NRL/MR/7441--94-7097

## Digital Mapping, Charting, and Geodesy Analysis Program Technical Review: Digital Nautical Chart Product 1

# DIGITAL MAPPING, CHARTING, AND GEODESY ANALYSIS PROGRAM TECHNICAL REVIEW: DIGITAL NAUTICAL CHART PRODUCT 1

Fig. 1 — Compass rose from DNC chart 12245

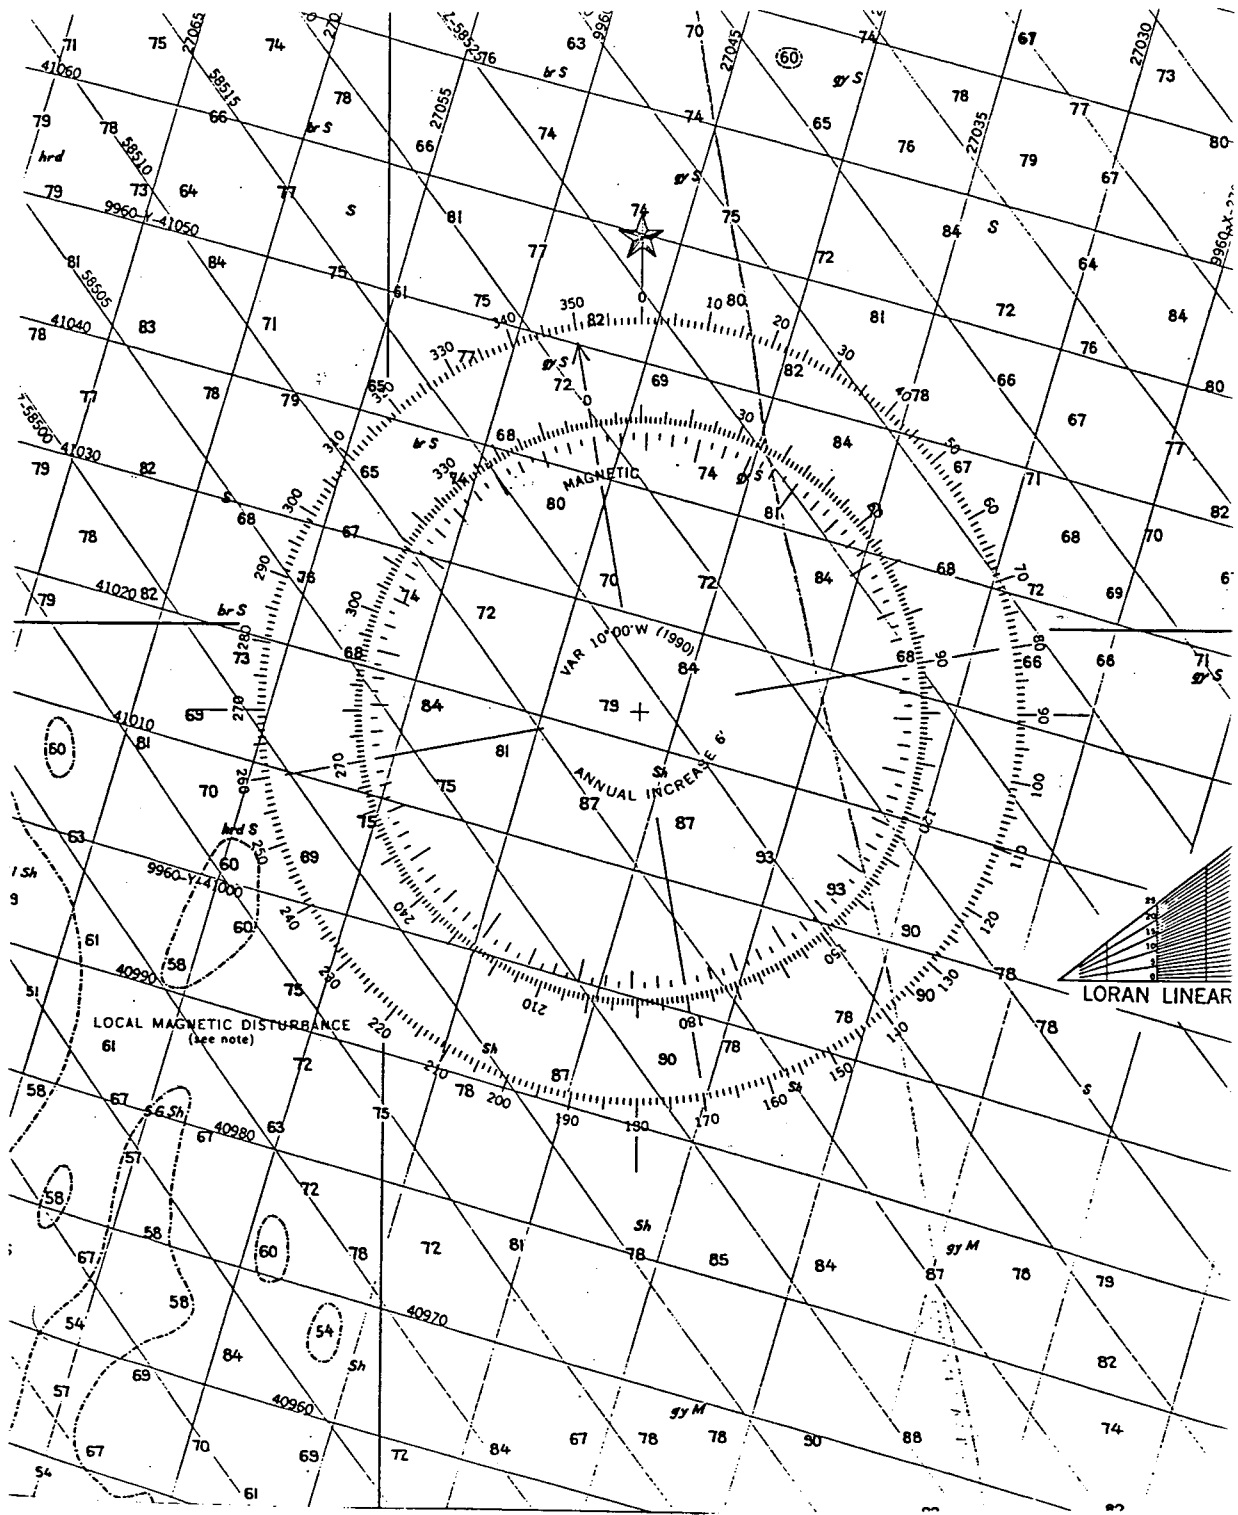
Compass roses (Fig. 1) are used to give information on magnetic variation for the areas in which they are placed. They tell the measure and direction of the variation, the year in which this measurement was made, and the expected annual increase in the variation. This data could easily be represented in the DNC with the creation of a new point feature (i.e., "Magnetic Variation") with three attributes containing the data mentioned above.

Fig. 2 — Magnetic variation lines from DNC chart 12200

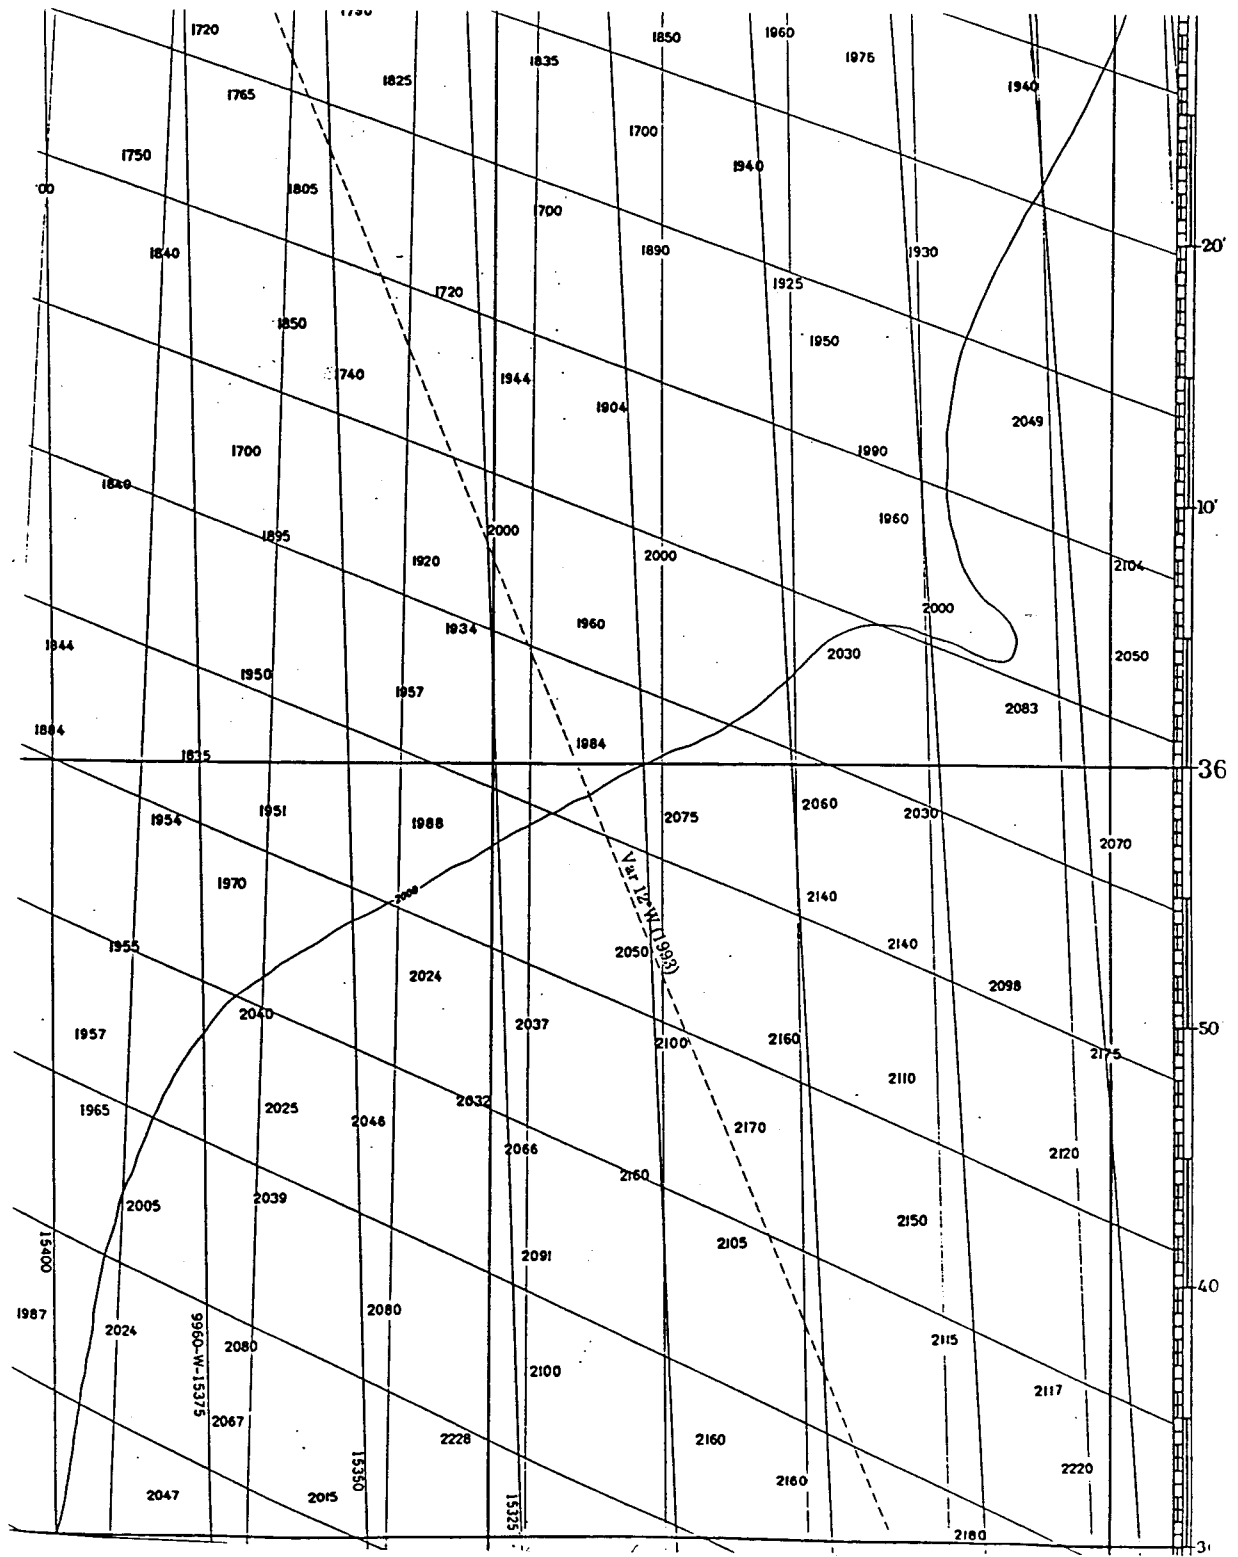
Related to the compass roses, there are also on chart 12200 lines of magnetic variation (Fig. 2). These are lines of constant variation giving the amount and direction of the variation and the year the variation was measured. These could be readily represented as line features.

Fig. 5 — Labeling of DNC features

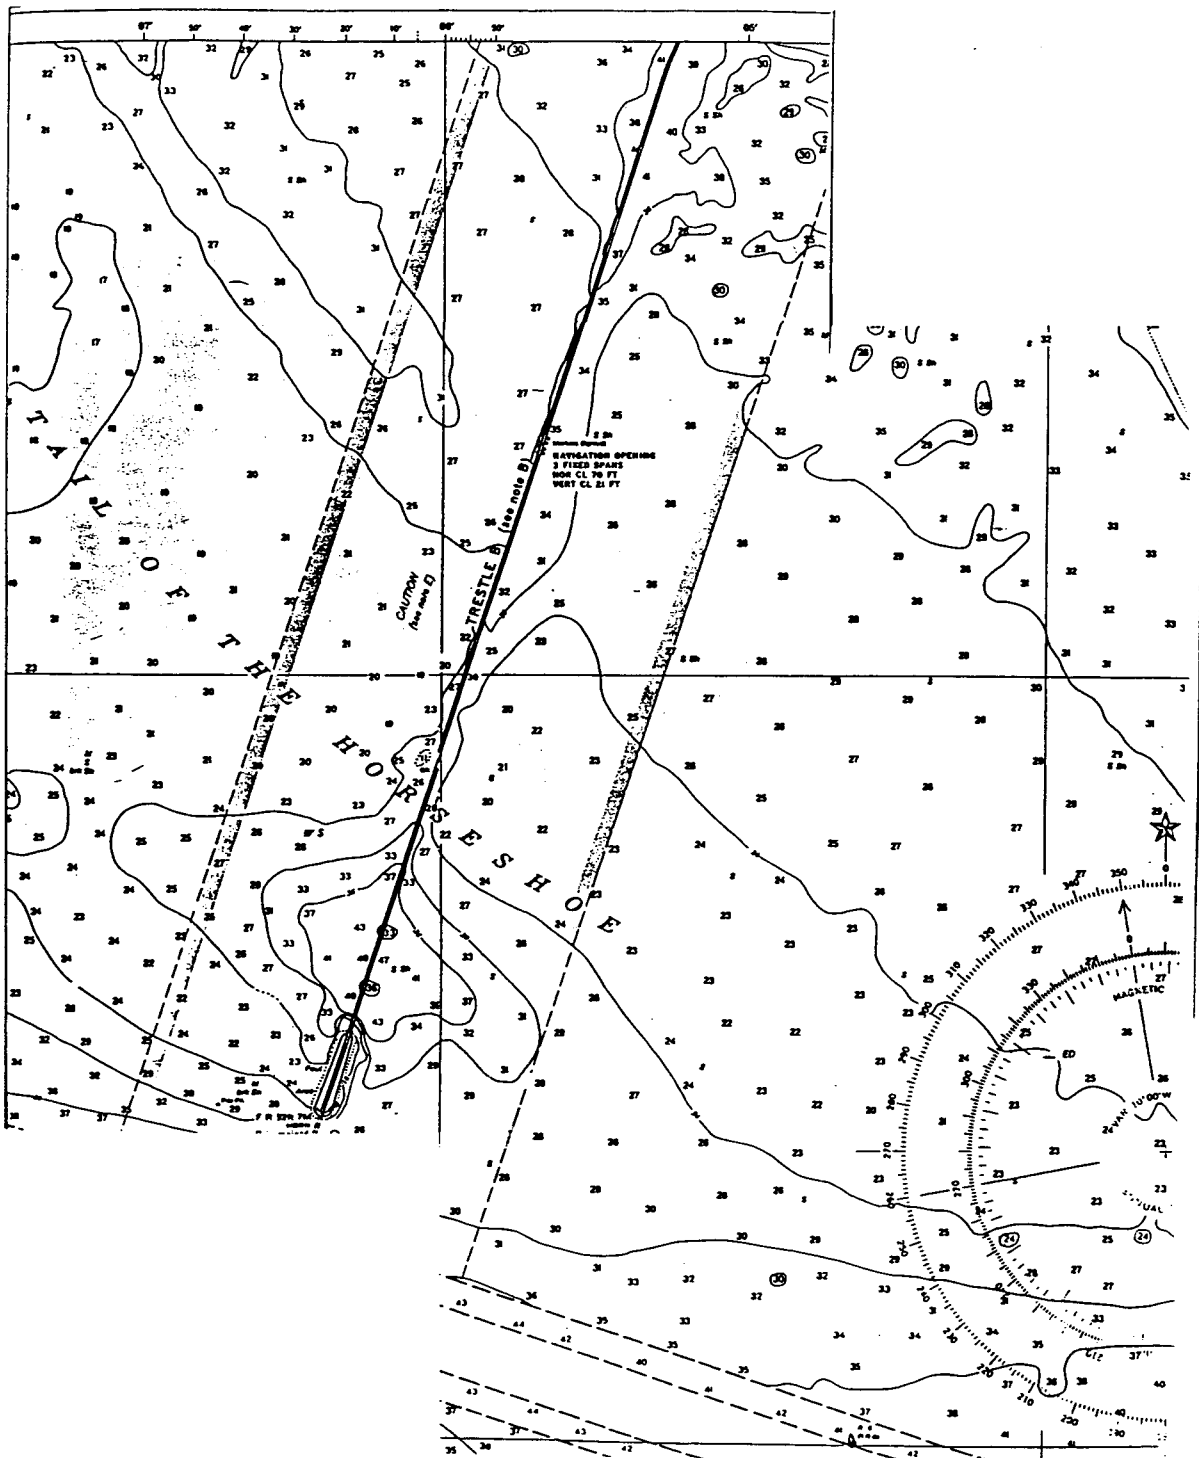
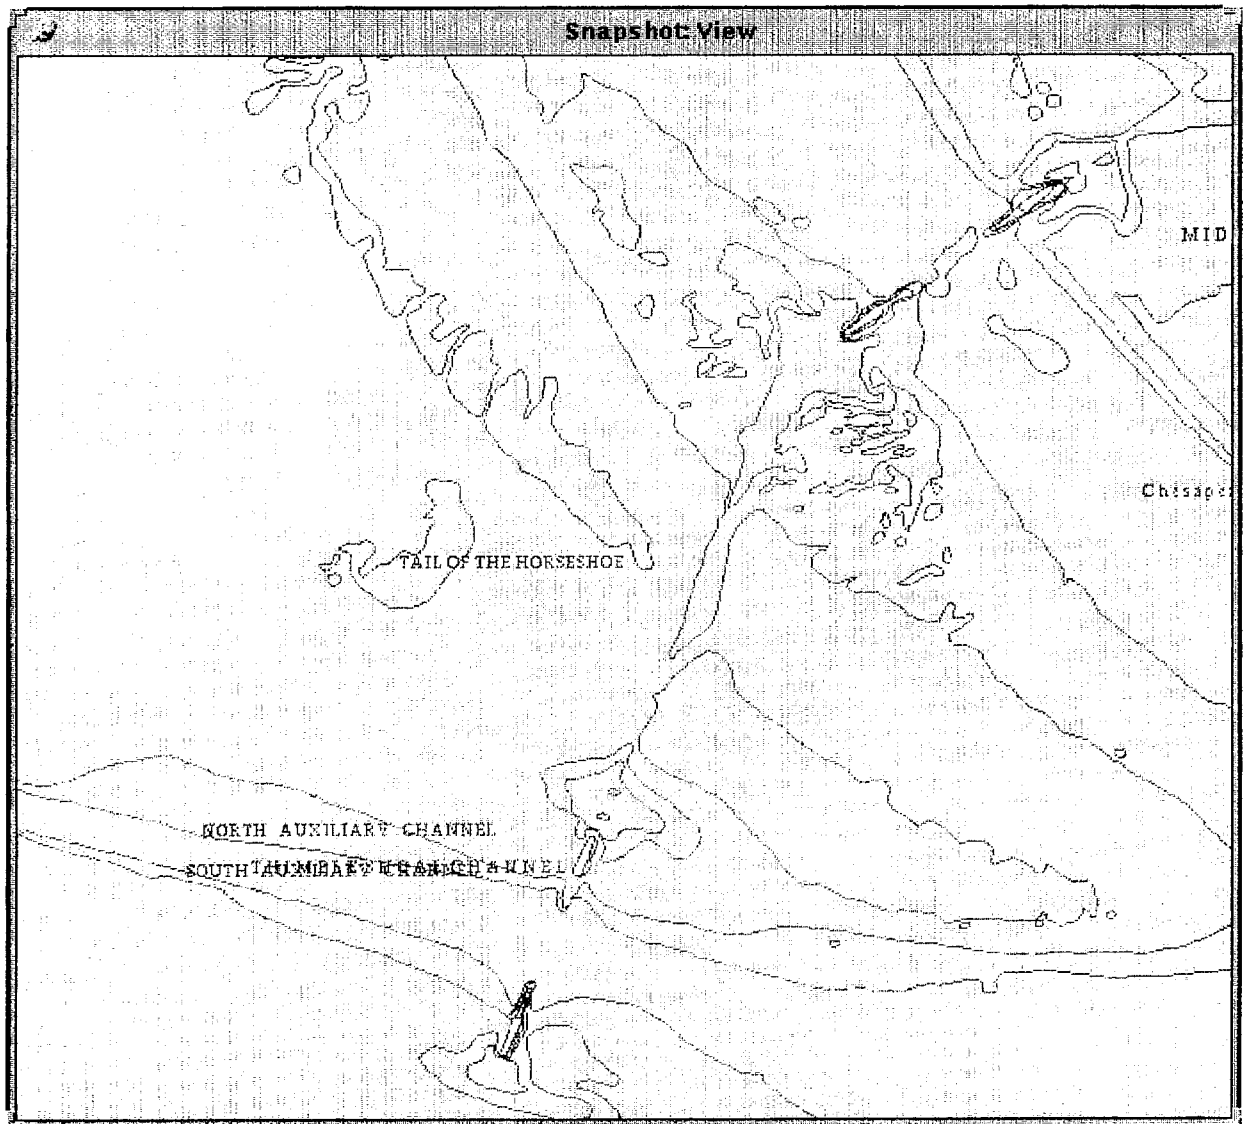
As mentioned in previous DMAP reviews of the DNC, text would be more descriptive if it followed the feature that it describes. Figures 4 and 5 represent labeling on the original paper chart

and in the DNC, respectively. As can be seen by comparing the two figures, the label in Fig. 4 follows the feature, but in Fig. 5 the label is almost perpendicular to the feature. This could cause obvious confusion.

Fig. 6 — Interchart inconsistencies due to different DNC chart scales in the Harbor library

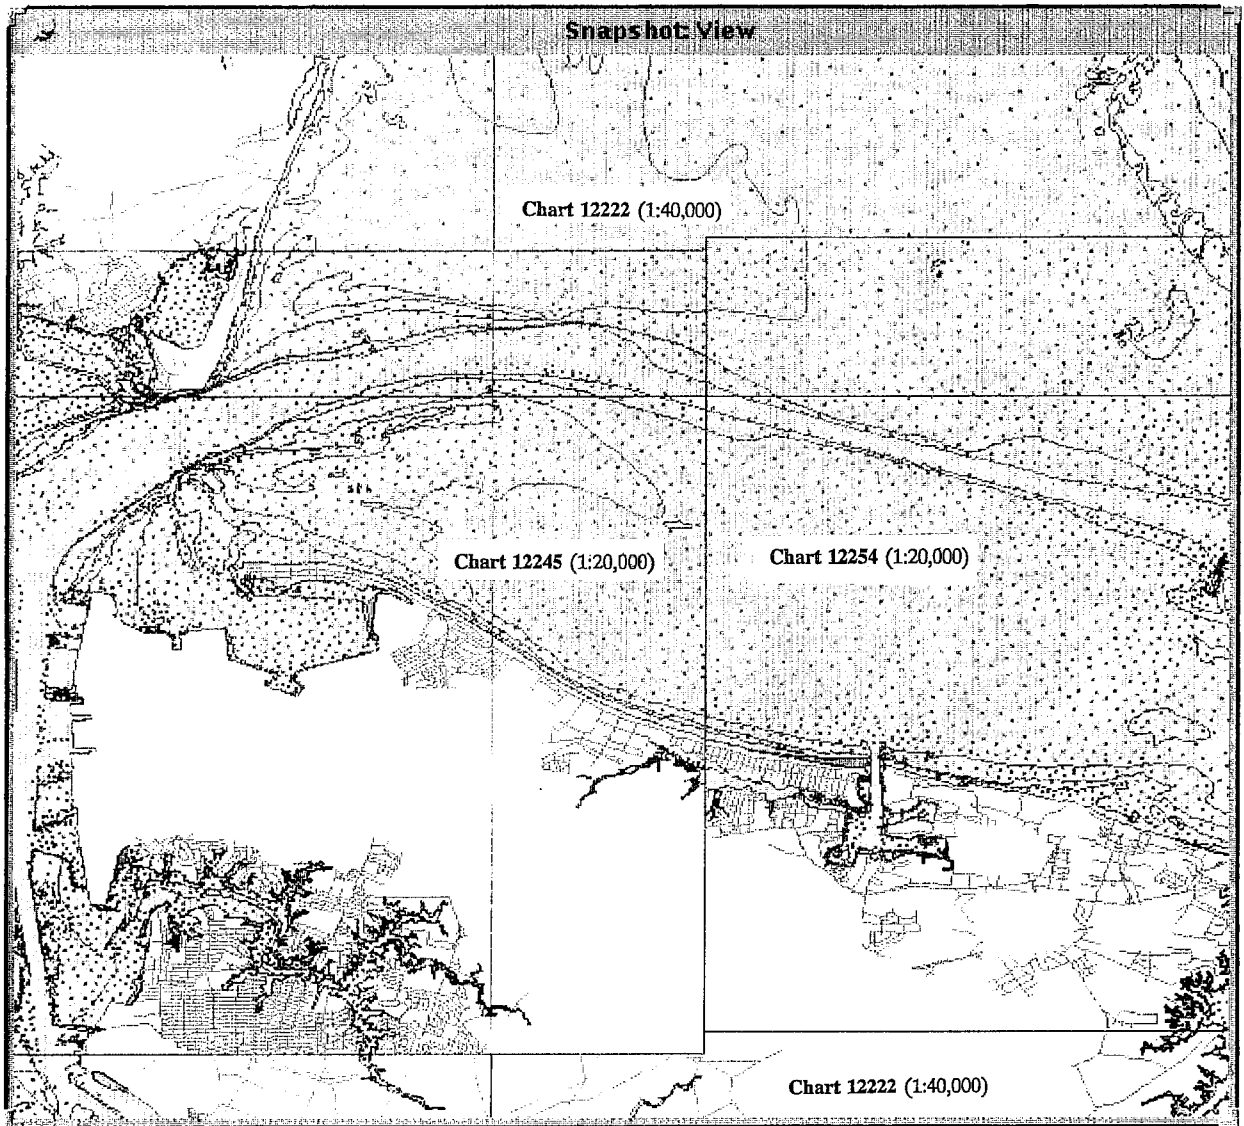
In several instances, where charts of different scales in the same library meet, an unexplained change in the data occurs. This change is especially true in the Harbor library since the library consists of three different charts with two different scales. As an example, Built-up Areas on chart 12222 (1:40,000) abruptly ends where chart 12245 (1:20,000) begins (Fig. 6). Chart 12245 has no Built-up Areas, but instead shows a dense network of streets. A similar situation occurs in Fig. 6 with Soundings in the Hydrography layer. There is a noticeable line across Chesapeake Bay where the low density of soundings on chart 12222 suddenly ends and the higher sounding density on charts 12245 and 12254 begins (both 1:20,000).

Fig. 7 — Depth contour areas in DNC Harbor library

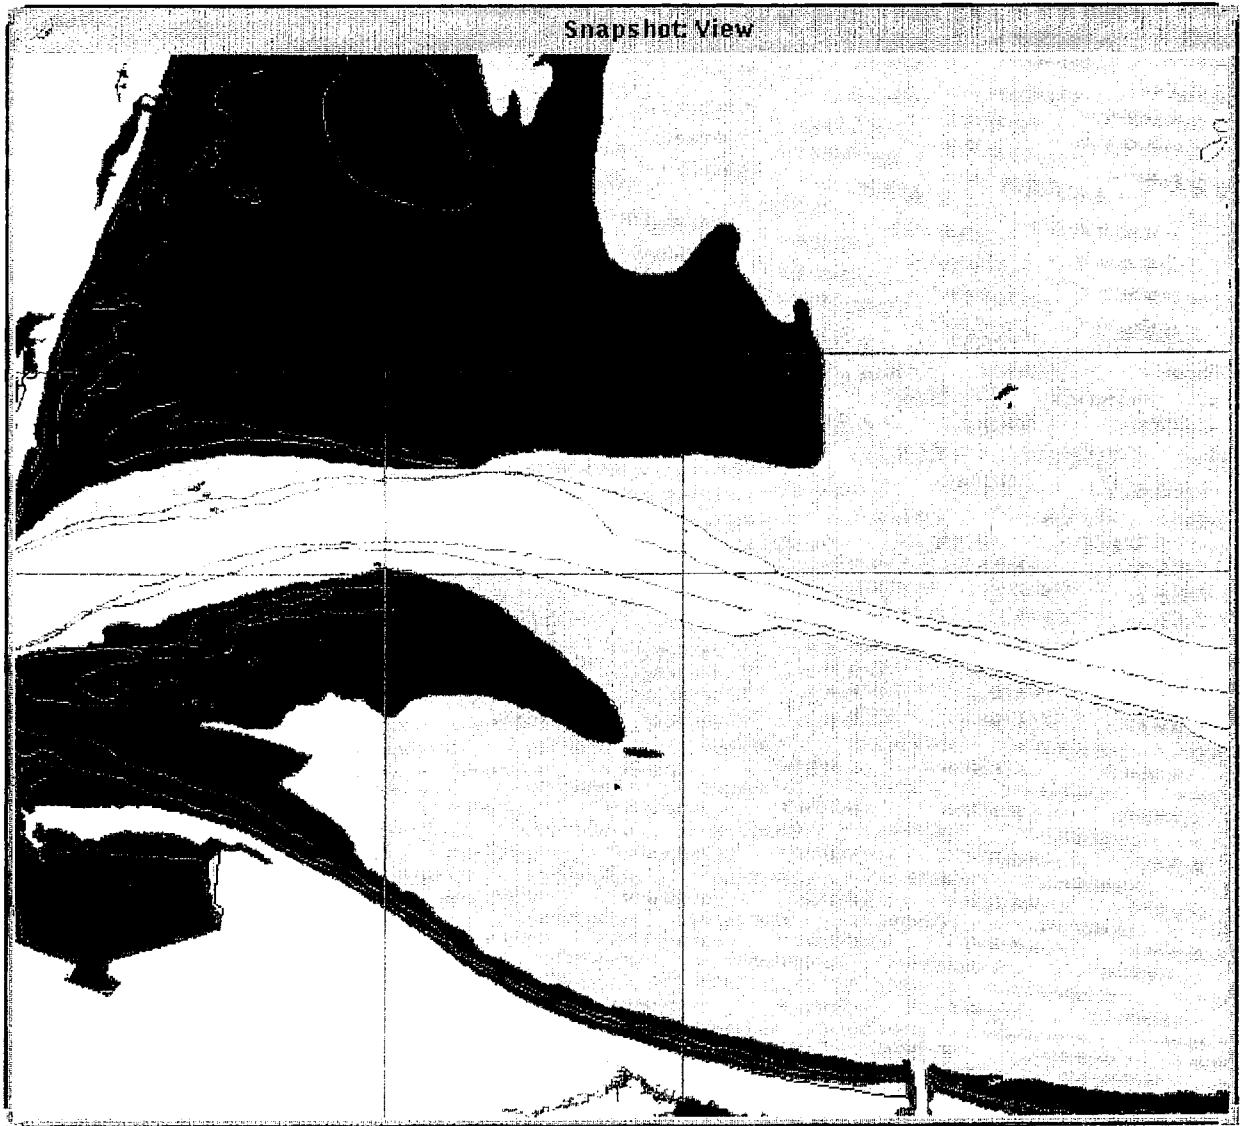
In the Harbor library, the 24-ft Depth Curve line is missing. The depth curve interval is 6 ft, but for some reason the 24-ft line is missing from paper charts 12222 and 12254. It is contained on chart 12245. To compensate for this, the 24-ft curve has mostly been removed from the digitized version of chart 12254 except for closed 24-ft contours. Comparison of Figs. 5 and 6 demonstrates this problem. Note that the DNC does not include text for contours. A spatial query would be required to obtain the contour value.

A more significant problem is where the Depth Curve areas of DNC Tiles 5 and 6 meet south of Willoughby Bank. Here a small portion of a larger Depth Curve area is contained on Tile 5 with the rest of the area on Tile 6 (Fig. 7). Both portions are entered into the DNC database with different Contour Value High attributes, causing them to graphically appear as two separate Depth Curve areas instead of one.
